FIELD CHANGE ORDER	NUMBER: PC736-F001, PC741-F001 PC743-F001, PC744-F001, PC746-F001
--------------------	--

APPLICABILITY: This "F" coded FCO should be installed on DECpc736, 741, 743, 744 and 746 computers at customer sites that require the BIOS support for 5.25", 360KB formatted diskettes. It will upgrade the PCs by replacing the BIOS ROM with revision level 1.22 on the Main Logic Board, P/N 54-22042-01.

Figure 1: Main Logic Board layout

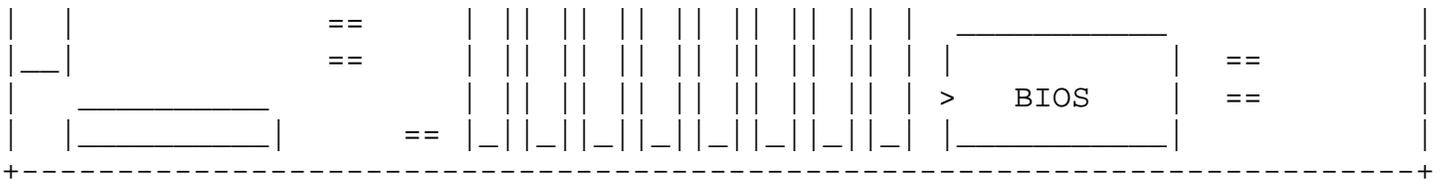
SOLUTION: Replace the BIOS ROM in location E48 on the Main Logic Board 54-22042-01 with BIOS ROM, P/N 23-397E9-00 (BIOS V1.22).

- DECpc LP Rev level is displayed during power up. Refer to sample screen display on Step 10 of suggested installation procedure in this document.
- For spares check the P/N printed on the BIOS ROM located on the Main Logic board (54-22042-01). It should be 23-397E9-00 V1.22, refer to Figure 1 in this document for visual assistance.

- Use the chip extracting tool to remove the old BIOS ROM, pay attention to the chip orientation and make a note of which way the notch is facing. Replace it with the BIOS ROM V1.22 (23-397E9-00) supplied in EQ-01671-01. Pay particular attention to pin alignment and chip orientation when you are replacing the BIOS ROM. The notch on the ROM should face the back of the chassis, refer to Figure 1 on previous page for visual assistance. The notch on the chip is indicated by ">". Check to make sure there aren't any bent pins after you've replaced the chip.
